River Thames Scheme

Summary of the Project Group's Response to Statutory Consultation

On behalf of the Project Group

Figure 4.1 Map of Ferris Meadow area with TPO's in yellow.

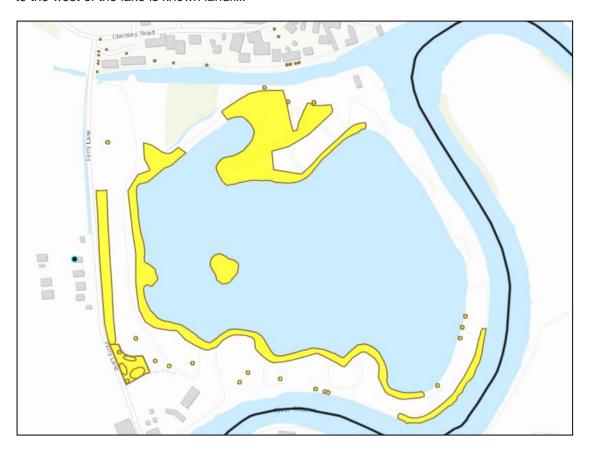
4.2.19 The Consultation presents seven options for the channel route at Ferris Meadow Lake, which has previously been presented to the Project Group (20th November 2023). In assessing these options, the Project Group would need to consider the visual impact, impact on protected trees, contamination issues and water quality of the lake. Based on the limited information and lack of

details, submitted to date, the Project Group is not able to indicate the preferred option(s) at this stage. It would be beneficial to see the detail and the various assessment outcomes to undertake an informed review prior to any decision being made. In addition, the development of this area would be of concern given that the lake side is covered by a large number of trees (see Figure 4.1 below) which are protected by Tree Preservation Orders (TPO's) and the area to the west of the lake is known landfill.
